Product Change Notification

May, 2016

Bourns® Model 70ABJ/Male Modular Contact *Change to Plastic Housing Design*

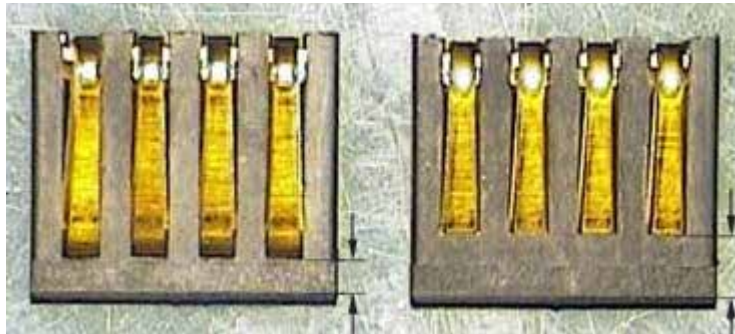
Bourns is pleased to announce that the [Model 70ABJ/Male Modular Contact](#) now features pick and place automatic capability. We have updated the plastic housing design of the Bourns® Model 70ABJ/Male Modular Contact to provide extra space for pick and place equipment. The current design has limited space and our customers cannot use automatic pick and place machines for manufacturing. The new design will improve production cycle in manufacturing.

Below is the change in the plastic housing design. While the form has changed, the fit and function are completely the same and all of the overall dimensions are the same. Now, more plastic housing space will be available for automatic pick and placement on the board.

*Current Housing
(with Limited Space)*

*New Housing
(with Increased Space)*
